I am writing about **traffic congestion in Mildenhall**. As you will know, the roads in the town can already become congested, especially during peak times and at certain pinch points. Residents worry this will only get worse with the town's population projected to grow. I am writing to offer suggestions about how the situation might be alleviated. I summarise three of the key issues below:

The context is of course the proposal to build around 1,000 homes — as well as 80-bed care units, up to five hectares of commercial land, land for a primary school and two early years facilities — in four phases on the west side of Mildenhall. This application is presently before West Suffolk Council for approval. With a significant inflow of new residents, many living in Mildenhall are concerned about access to services and traffic congestion. Also relevant is the proximity of the Mildenhall Hub, which brings its own traffic challenges.

Figure One: Indicative phasing strategy (Source: Concertus, 2023).¹

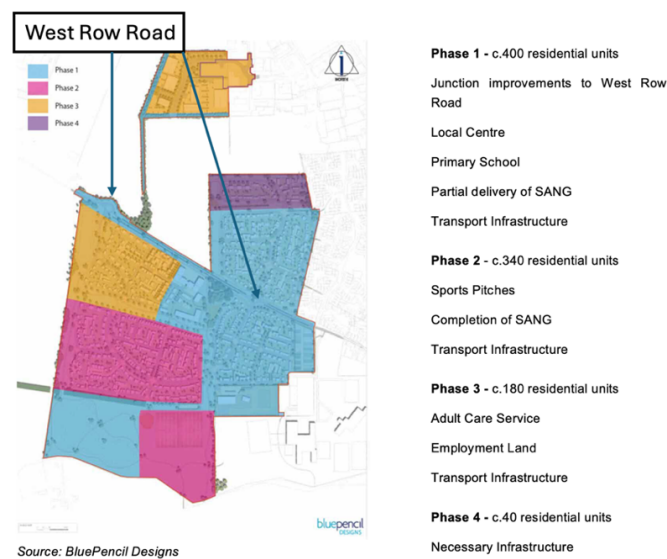
Without action, the housing plan risks an unacceptable increase in traffic as existing and new residents use **Queensway / West Row Road**, in addition to visitors to the Hub. The traffic survey submitted as part of the plan suggests residents in around 780 of the new homes (phases 1, 2 and 4 of the development) would have **West Row Road** as the only ingress / egress point (see Annex A below, on p.3).

ANNEX A: Figure One below shows how the only ingress / egress point for new houses in phases 1, 2 and 4 of the development, as well as a portion of phase 3 (the blue, pink and purple, and part of the yellow, areas) will be **West Row Road**, already used both by local residents and those accessing the amenities at the site of the **Mildenhall Hub** nearby. Figure Two below shows the proximity of the planned development to the Mildenhall Hub site.
